Product Change Notice (PCN)

PCN Number: PCN-0381131R-01

- CLS0501M
- CLS0501M-L152

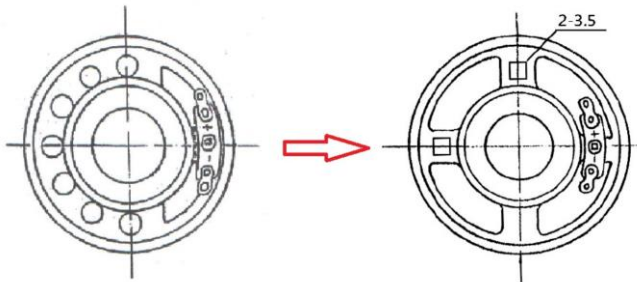
- Tooling plate outdated upgraded

- SPL increased from 80dB to 84dB
- Frame shape has changed (Image Below)
